**SECTION 00 91 03  
ADDENDUM NUMBER 3**

**DATE:** MARCH 6, 2020

**PROJECT:** CITY OF AURORA - CITY CLERK AND BUDGET DEPARTMENT  
RENOVATION  
44 E. DOWNER PLACE  
AURORA, ILLINOIS 60507

**PROJECT NO:** 19-130-1267

### **4.04 DRAWING E210 - ELECTRICAL FIRST FLOOR & REFLECTED CEILING DEMOLITION PLAN**

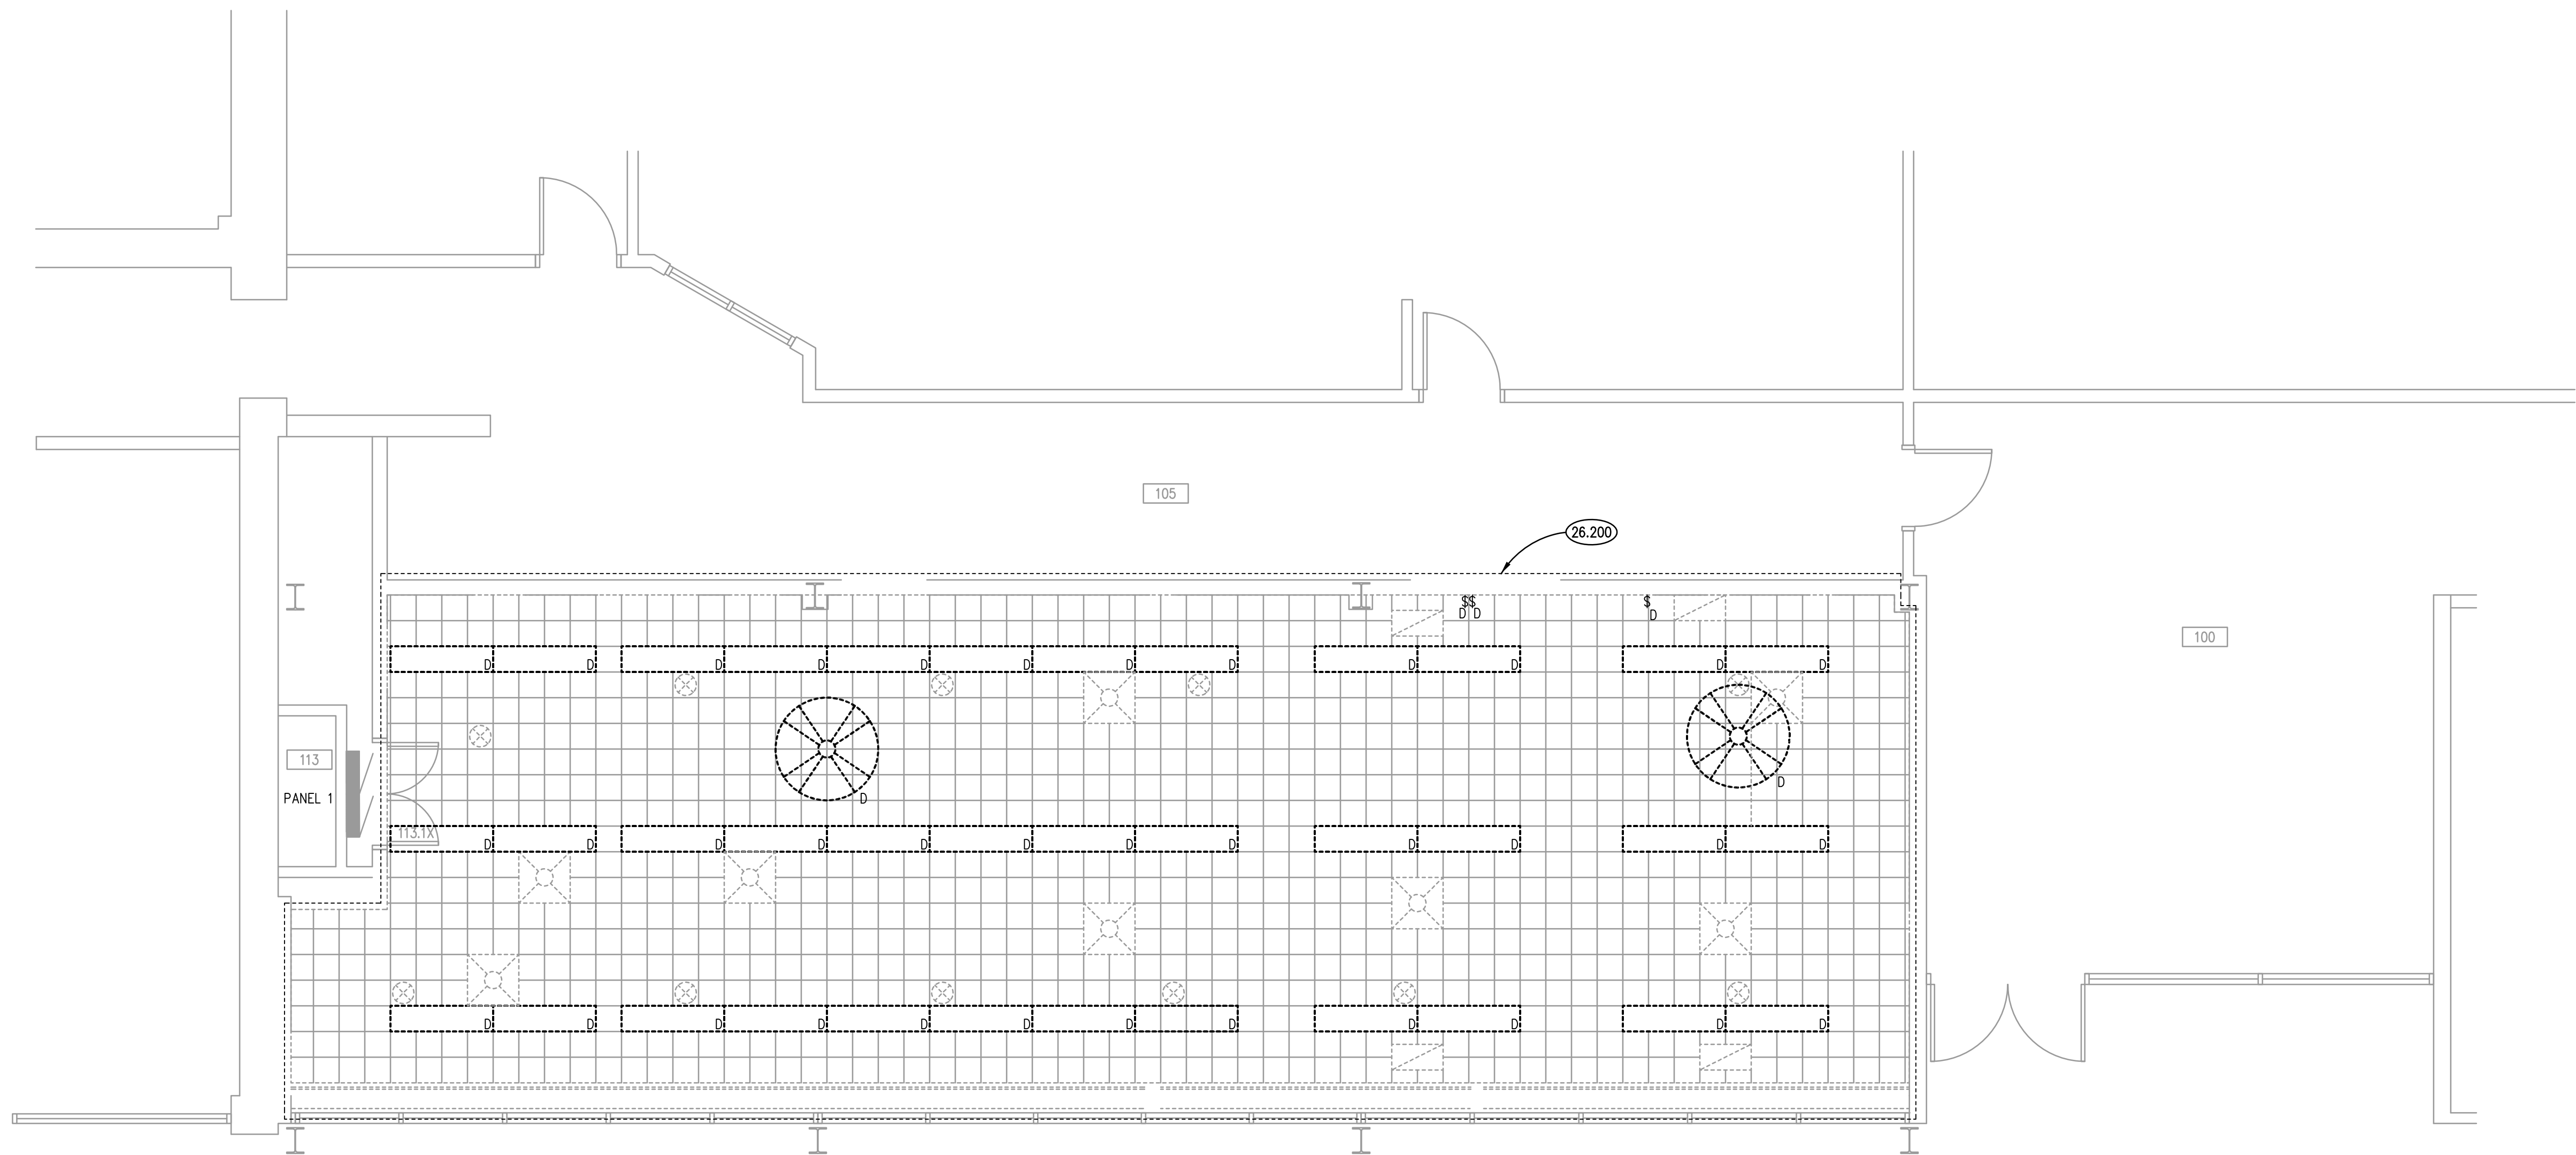
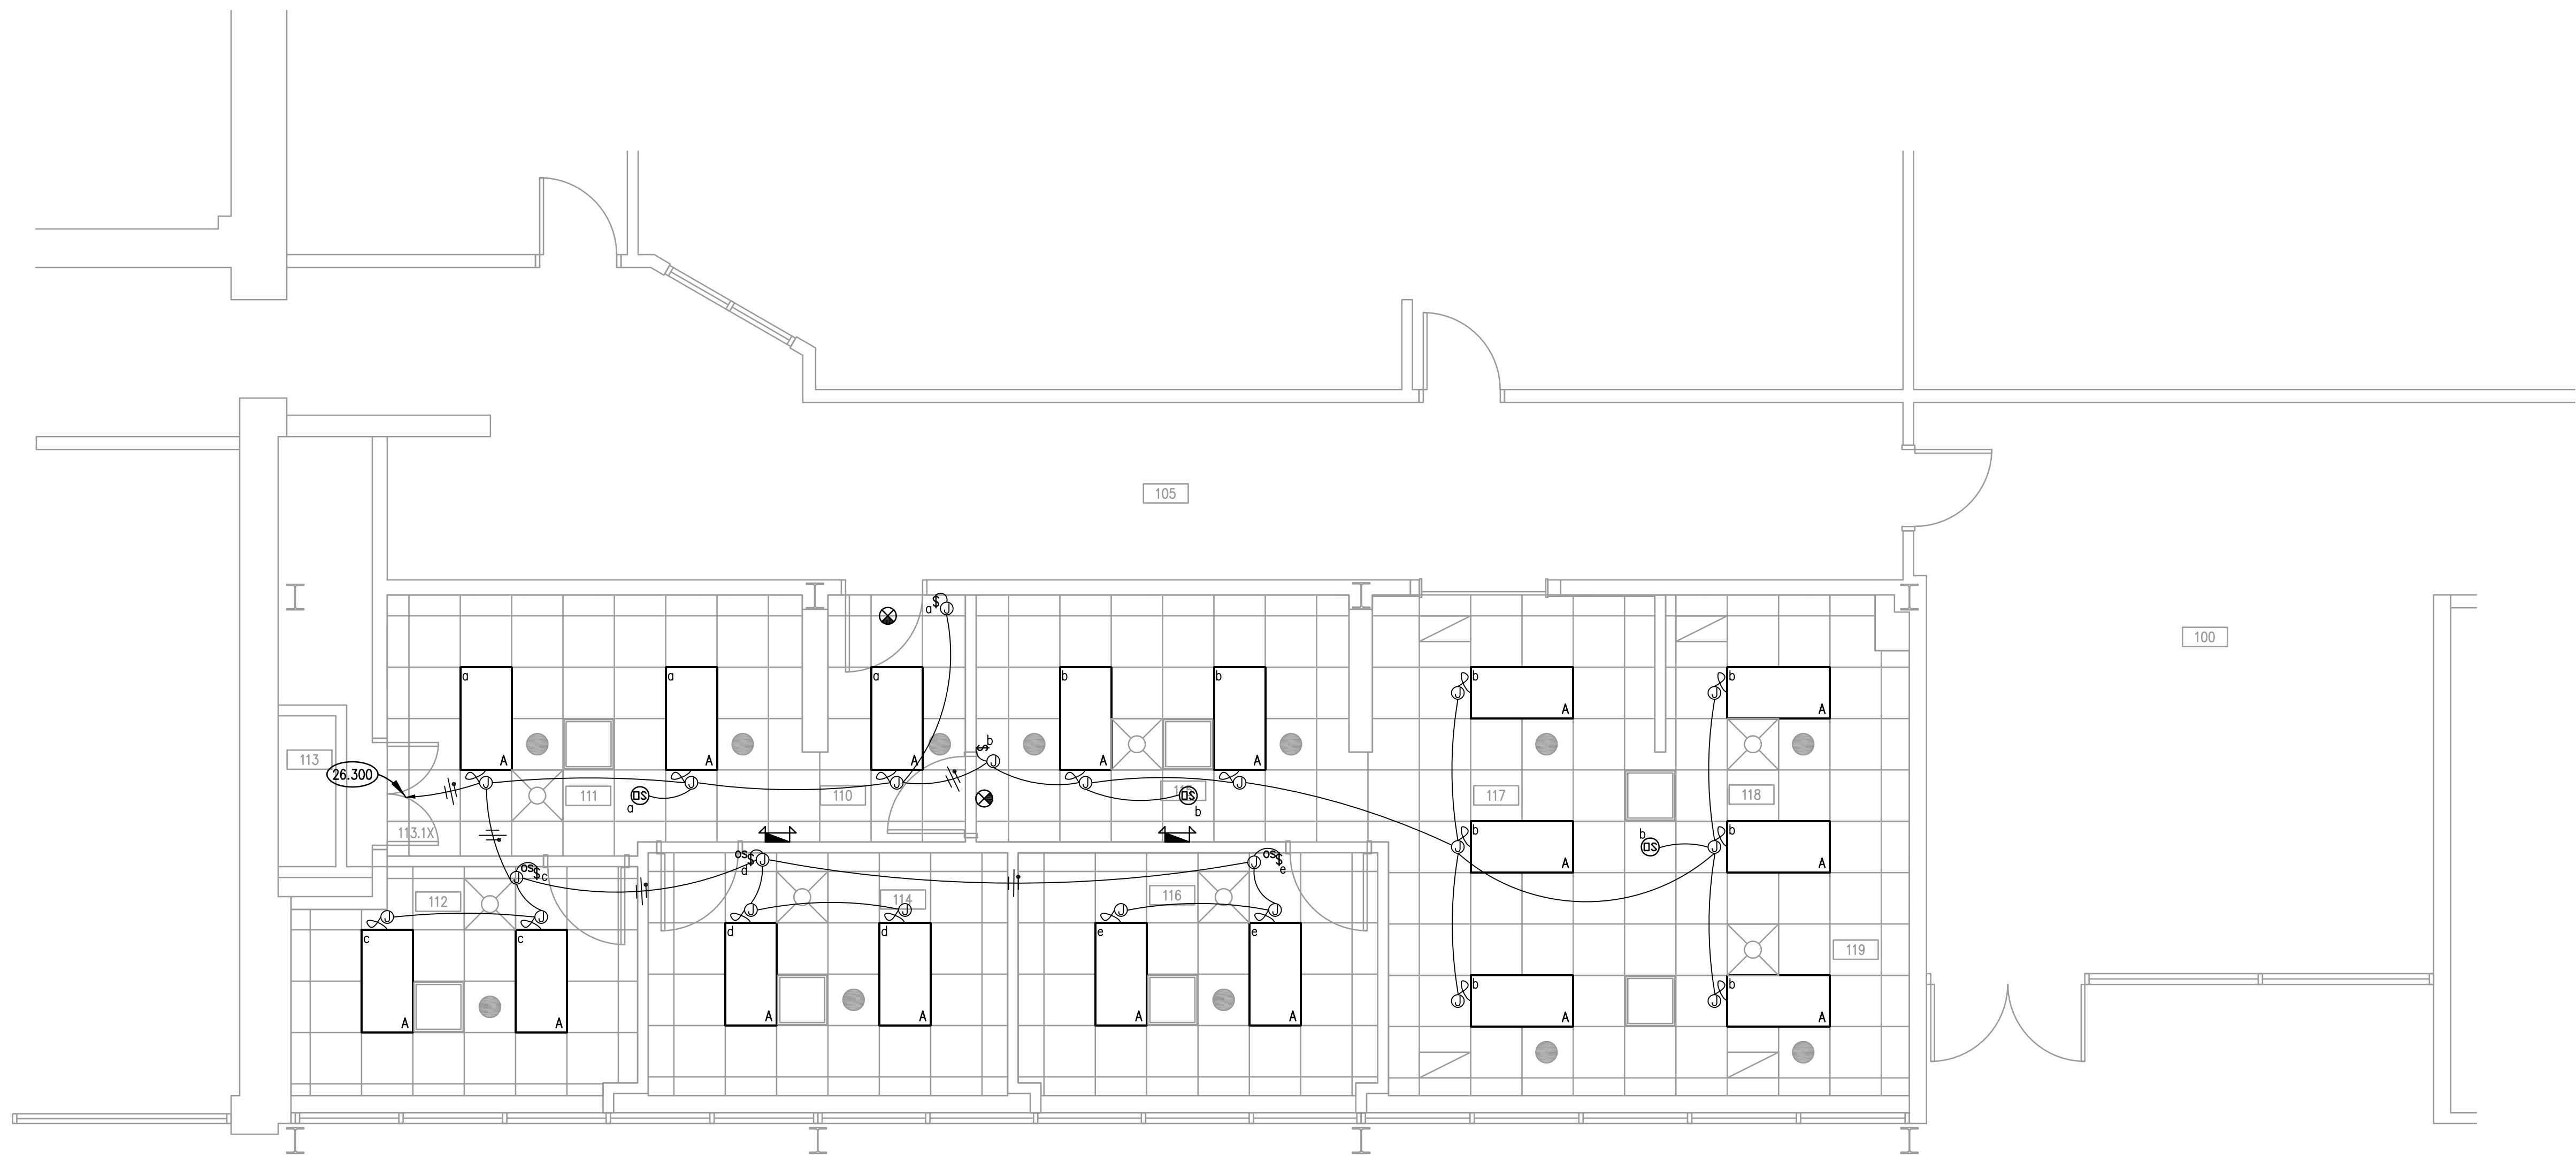
- A. See attached re-issued Sheet E210 for Revision Cloud 2 items.

### **4.05 DRAWING E310 - FIRST FLOOR ELECTRICAL POWER PLAN**

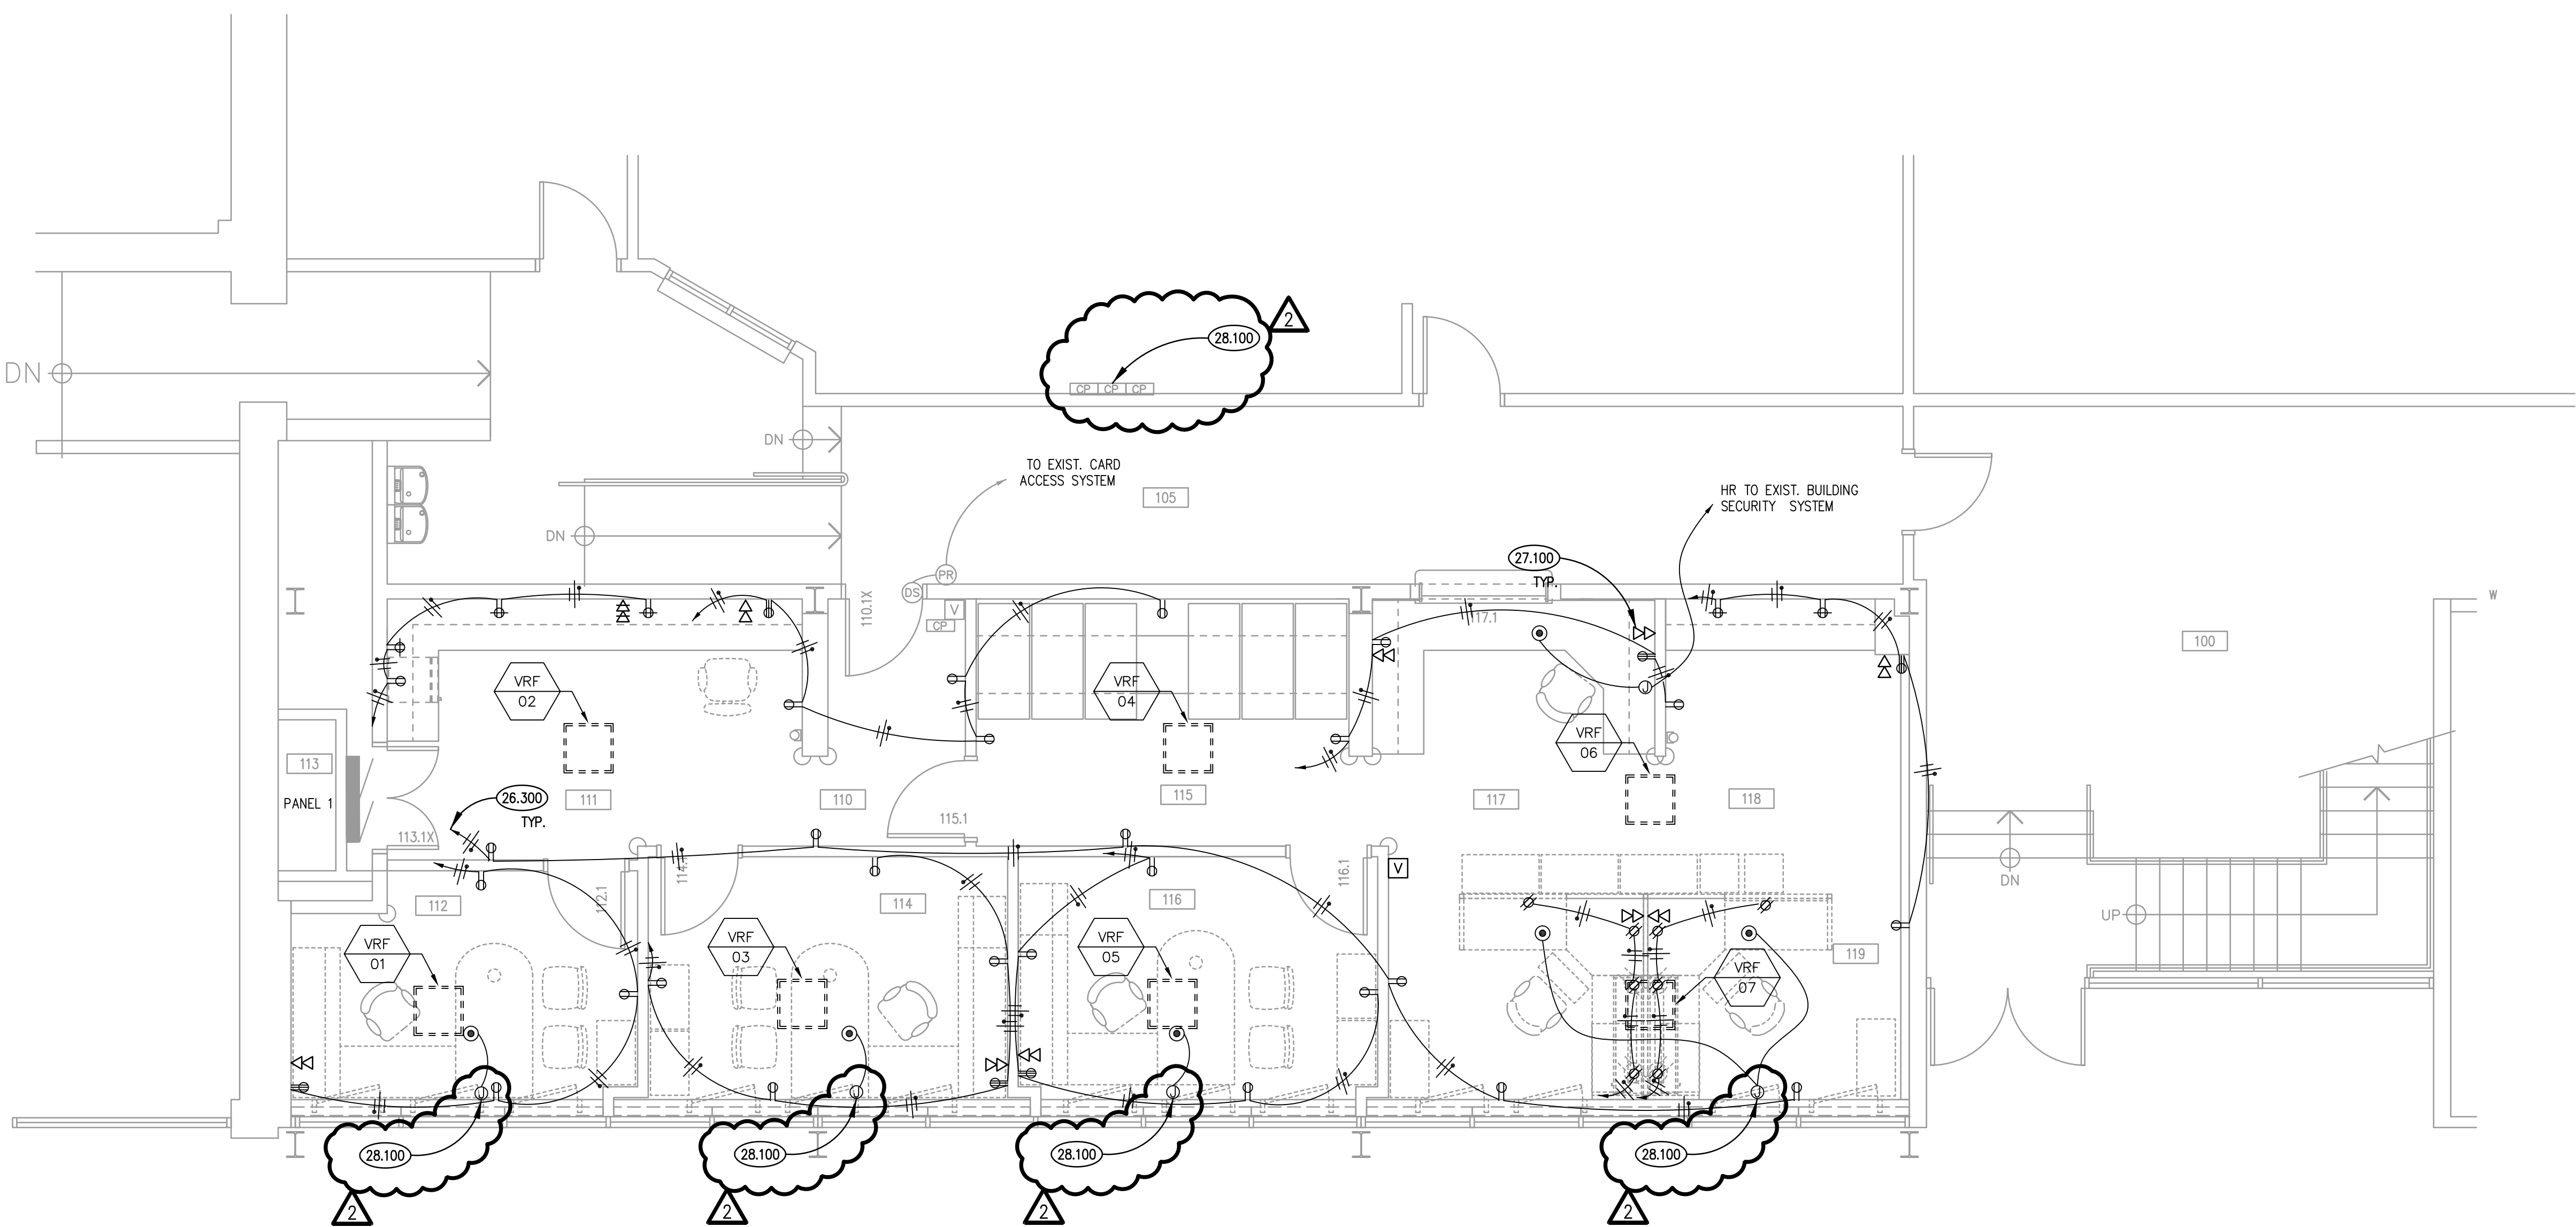
**2.02 Can you please provide clarification on drawing E310 relating to the QTY-6 locations by desks with homerun to existing building security system?**

- A. See attached re-issued Sheet E310 for Revision Cloud 2 items.

A. Contractor to provide duress button and wiring back to Coordinate exact security requirements with Owner's security representative - Alarm Detection Systems, Inc.

28.100 PROVIDE DURESS BUTTON AND HOMERUN TO EXISTING SECURITY PANEL LOCATED IN OFFICE ACROSS CORRIDOR 105. FOR BIDDING PURPOSES ONLY. ASSUME 22 AWG, 4 WIRE STRANDED CABLE. COORDINATE EXACT DEVICE AND WIRING REQUIREMENTS WITH OWNER'S SECURITY VENDOR PRIOR TO INSTALLATION. ALARM DETECTION SYSTEMS, INC. - (630)844-6302. SYSTEM # 80014254, ACCT # 9611.
